# ACCESS COMPLIANCE REPORT

Proposed Child Care Centre at  
31-32 PARK AVE, KINGSWOOD  
NSW 2747

## Development Application

BASEMENT

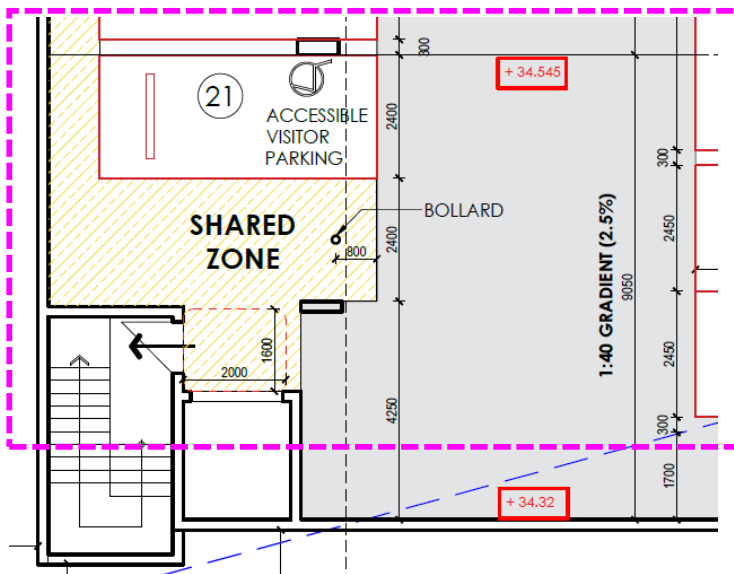
- Access to all the spaces within the Child Care Centre has been provided by the means of walkways & ramps that complies with AS 1428.1.
- An accessible parking space with shared zone and bollard is provided in the Basement. The shared zone and the lift access is within a 1:40 gradient complying with AS 1428.1.
- The common entry lobby in the Ground floor is accessed by the means of walkways & ramps that complies with AS 1428.1.

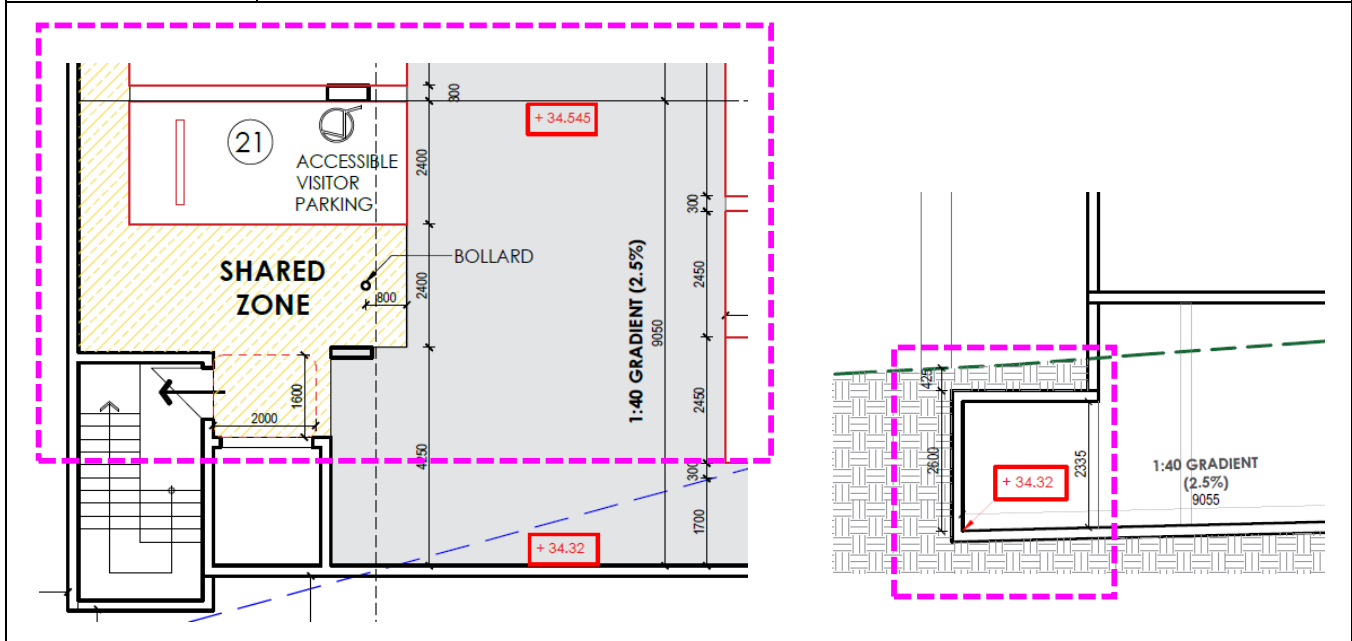
<i>BCA Part D3.5 Accessible Carparking</i>	
<b>Requirement</b>	1 space for every 100 car parking spaces or part thereof.
<b>Compliance Comments</b>	<ul style="list-style-type: none"> <li>- 1 accessible parking space with a shared zone has been provided to comply with the requirement for the proposed Child Care Centre.</li> <li>- The entry from parking space to the building is by the means of lift in the basement.</li> </ul>

## GROUND FLOOR

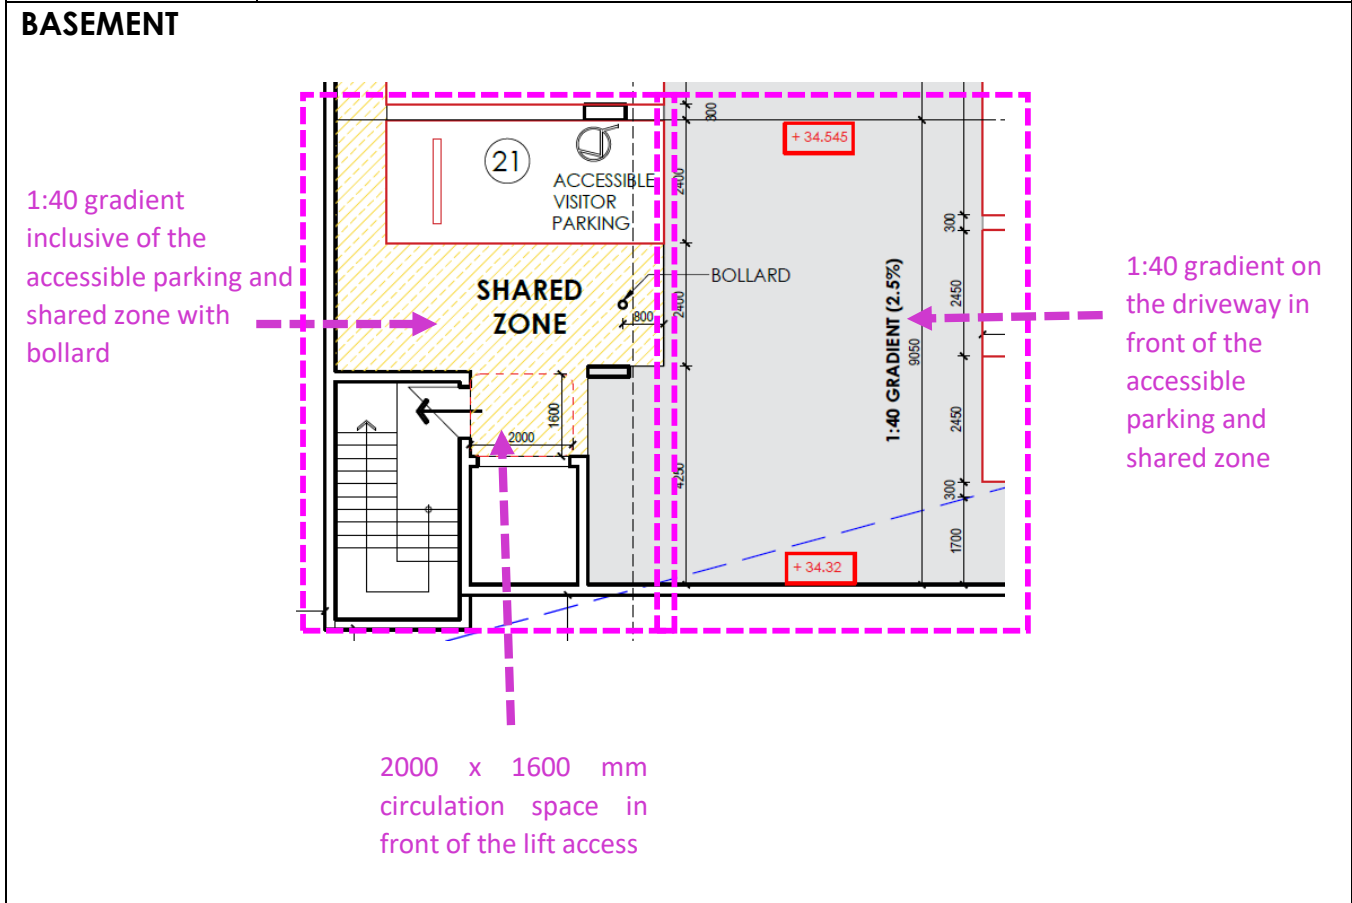
- Access to all the spaces within the Child Care Centre has been provided by the means of walkways & ramps that complies with AS 1428.1.
- An accessible parking space with shared zone and bollard is provided in the Basement. The shared zone and the lift access is within a 1:40 gradient complying with AS 1428.1.
- The common entry lobby in the Ground floor is accessed by the means of walkways & ramps that complies with AS 1428.1-2009

1470 X 1450 mm circulation spaces on either side of toilet entry complying with AS 1428.1-2009

1470 X 1450 mm circulation spaces on either side of access complying with AS 1428.1-2009

1470 X 1450 mm circulation spaces on either side of kitchen and toilet entry complying with AS 1428.1-2009

1470 X 1450 mm circulation spaces on either side of access complying with AS 1428.1-2009

1470 X 1450 mm circulation spaces on either side of access complying with AS 1428.1-2009

1470 X 1450 mm circulation spaces on either side of access complying with AS 1428.1-2009
